## **CC1020 Errata Note 001, rev. 1.0**

**CC1020 Errata Note 003, rev. 2.0**

**CC1020 Errata Note 004, rev. 1.0**

**Figure 1: Schematic diagram of the input/output matching network**

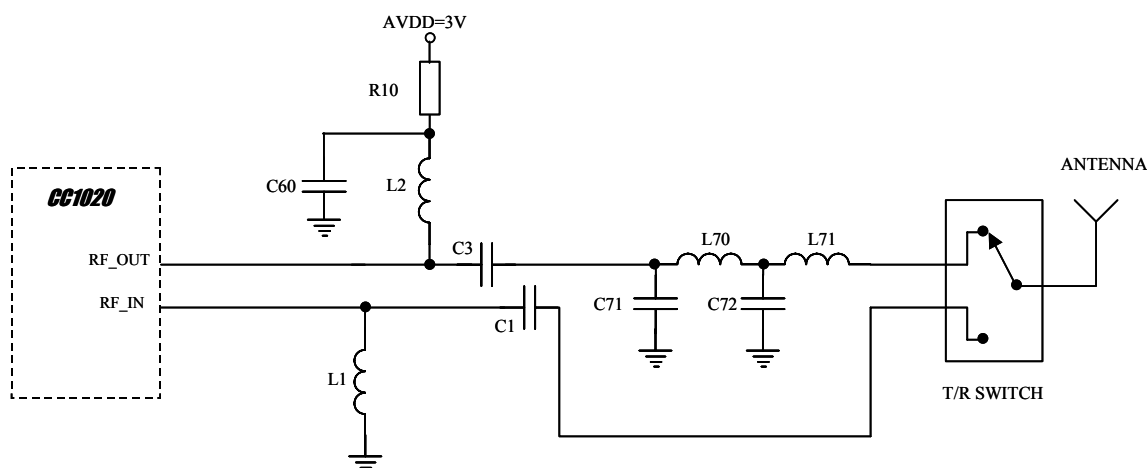
When using high output power settings with the CC1020EMX-433 v1.0 the recommended maximum voltage level on the RF\_OUT pin (pin 21) is exceeded. This may cause a drop in output power over time, particularly if the transmit duty cycle is high. Power drop has only been observed on the 402 – 470 MHz version of the reference design (i.e. the CC1020EMX-433 v1.0) as the 804 – 940 MHz version has a considerably lower voltage swing during transmit.

For the CC1020EMX-433 v1.0 operating at 3.0 V, 402 – 470 MHz, with an output power of +10 dBm, the output power has been observed to drop by more than 3 dB over weeks with continuous transmit operation. The majority of the power drop occurs during the first hours. For operation above 3.0 V the drop can be slightly worse, while for supply voltages lower than 3.0 V, the drop will be less.

By lowering the load impedance “seen” by the CC1020 power amplifier, the output power drop is avoided. The series resistor R10 is added to reduce the DC voltage at the RF\_OUT pin. Finally, for the CC1020EMX-433 the filter topology has been changed from a  $\pi$ -type filter to a T-type filter in order to achieve a better combination of reflection factors for the harmonics. This change applies to the 433 MHz frequency only. Altogether, these changes, which are implemented in the new CC1020EMX reference design v2.0, remedy the output power drop problem. The new solution increases the current consumption in transmit mode by typically 3 mA at maximum output power.

Copy the CC1020EMX reference design v1.1 (4-layer), v2.0 (2-layer) or newer.

A schematic diagram of the input/output matching networks for the CC1020EMX reference design v2.0 is shown in *Figure 1*.

The corresponding component values of the CC1020EMX reference design v2.0, which is a 2-layer reference design with single-sided assembly, can be found in *Table 1*. It should be noted that all inductors used in the RF matching network are 0402 low-cost multilayer inductors.

**Figure 1: Recommended PLL calibration procedure**

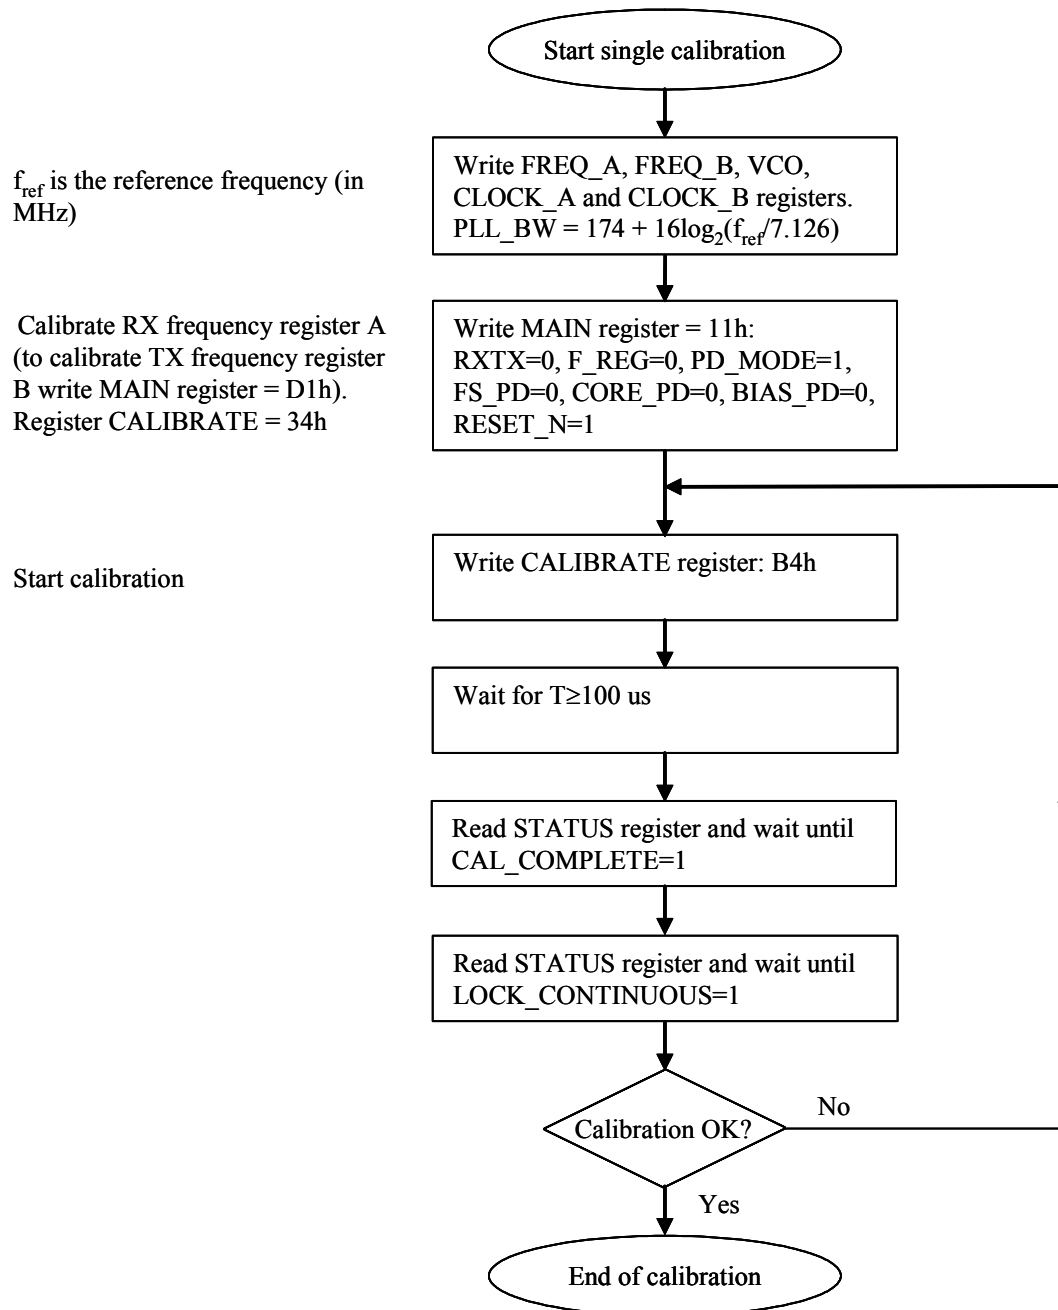
When using a 14.7456 MHz crystal frequency the CC1020 calibration (monitored by steps 2 and 3) typically lasts 27 ms. However, it has been observed that the CAL\_COMPLETE indicator in the STATUS register is unreliable during the first 100  $\mu$ s after initiating the calibration. As a result step 2 might indicate calibration complete too early, i.e. before the actual calibration has actually completed. In such a situation step 3 (LOCK monitoring) is executed during instead of after calibration. In order to avoid this inconsistency, a waiting period of at least 100  $\mu$ s between calibration start and the start of the polling should be applied using one of the following methods:

In less than 10 ppm of all PLL calibrations performed it was observed that CC1020 did not achieve LOCK even when introducing a 100  $\mu$ s wait period before polling of [STATUS.CAL\_COMPLETE] was initiated. The reason for no LOCK still occurring, even when calibrating the PLL with this small wait period, is due to the PLL calibration procedure making an erroneous frequency measurement causing the PLL calibration algorithm to choose a wrong capacitor array setting producing a no LOCK situation. For this reason it is important to control that the PLL calibration achieves LOCK and recalibrate if it does not.

Calibration starts when CALIBRATE.CAL\_START is set to 1 as shown in figure 1. The PLL is then set to open loop and the internal VCO control voltage set to a value given by CALIBRATE.CAL\_ITERATE[2:0] = 4<sub>h</sub>. Based on this value a capacitor array is selected and when the calibration is completed the PLL loop is closed.

For those users who have not already implemented a recalibration procedure in software it is strongly recommended to avoid polling [STATUS.CAL\_COMPLETE] until 100  $\mu$ s has elapsed following calibration start, then monitor LOCK after calibration complete and, if LOCK is not achieved, recalibrate until LOCK is successfully achieved. The recommended calibration procedure, including recalibration, is provided in figure 1.
